From: rambabu.g@modiproperties.com [mailto:rambabu.g@modiproperties.com]
Sent: 11 07 2017 18:44
To: Soham Modi <sohammodi@modiproperties.com>
Cc: Madhu T. <madhu@modiproperties.com>
Subject: Regarding recheck of villas diagonals for 9 villas.

SITE PLAN

Description	Direction	Owners & Developers :	Date :	12.1.2017	Promoted by
		MODI REALTY (MIRYALAGUDA) LLP	Prepared By :	Madhav Bhatt	Modi Properties &
		Project Name & Phase :	Approved By :	Soham Modi	Investments Pvt. Ltd.
					N T S
SITE PLAN - SOIL TESTING PITS

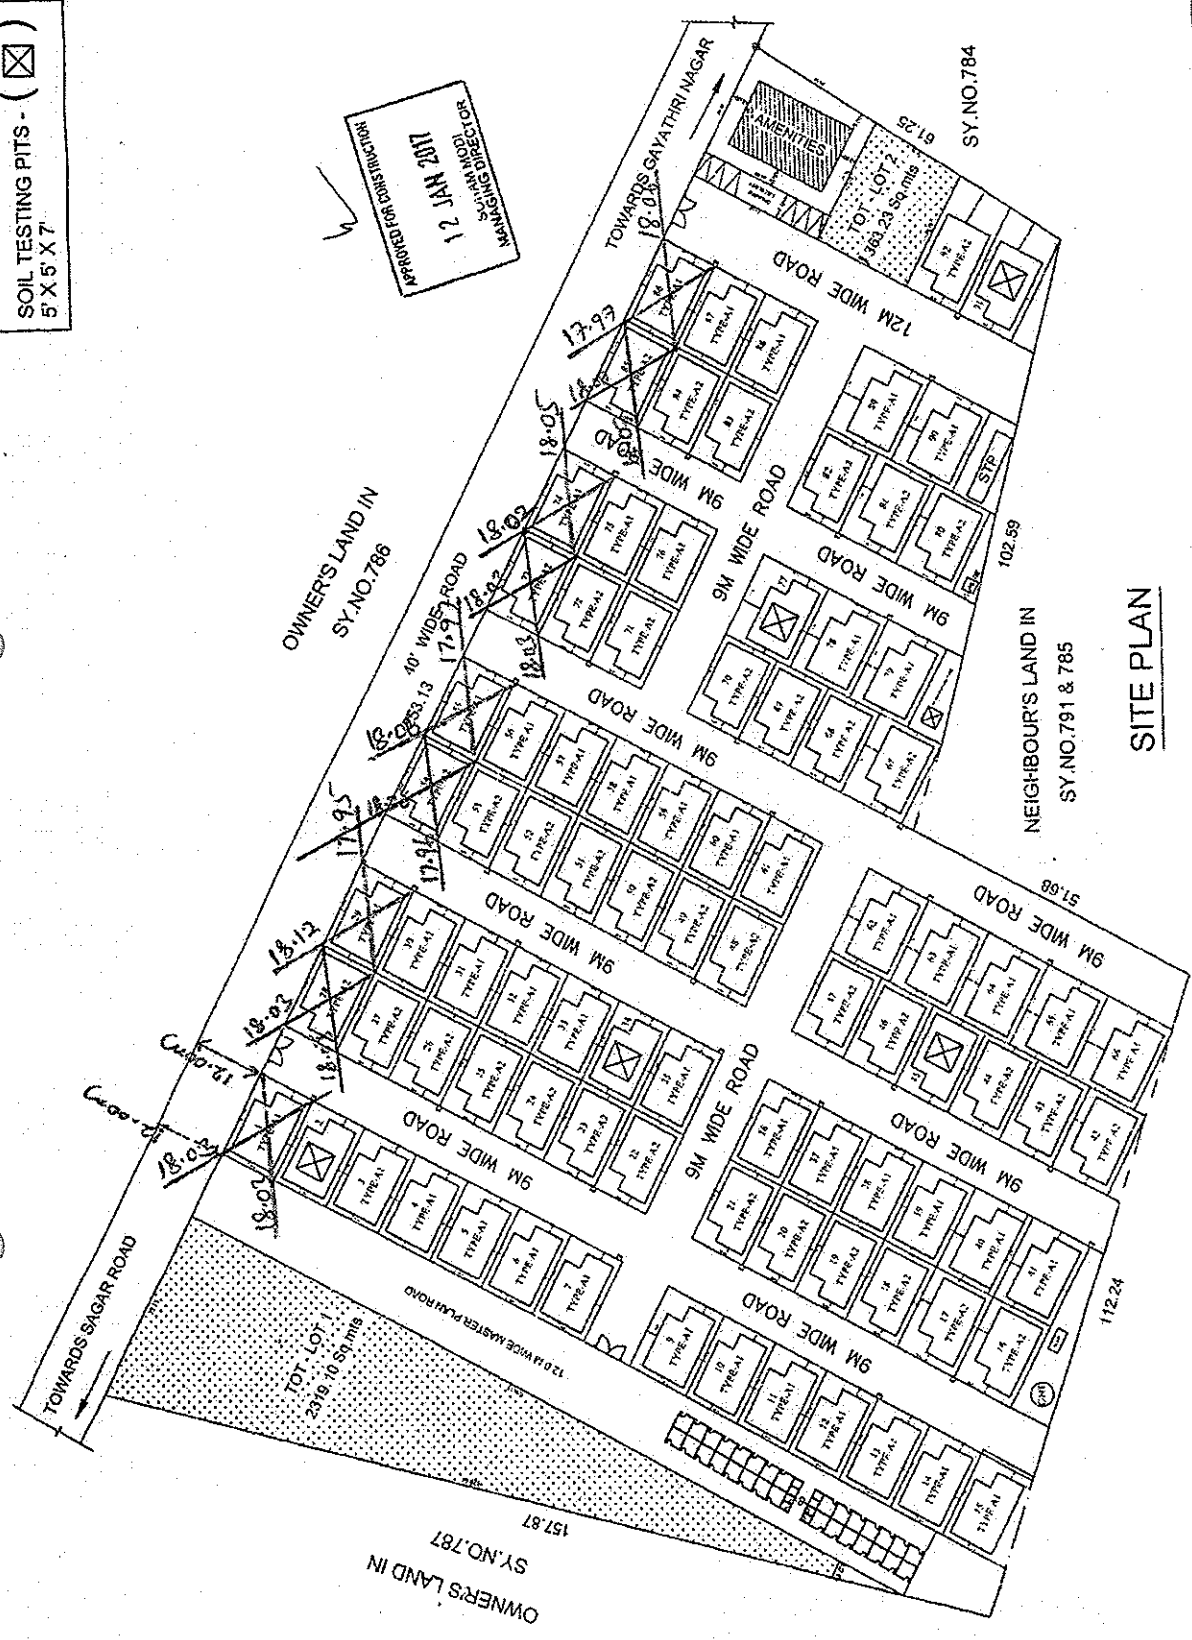
after rechecking of villas of 1,28,29,54,55,73,74,85,86. we found only three villas are correct in measurements & diagonal (villa nos. 1,28,73)

Balance villas are (29,54,55,74,85,86) are not matching in diagonals.

Sir, for villa no. 10.00 x 15.00 m we required diagonal measurement is 18.03 m.
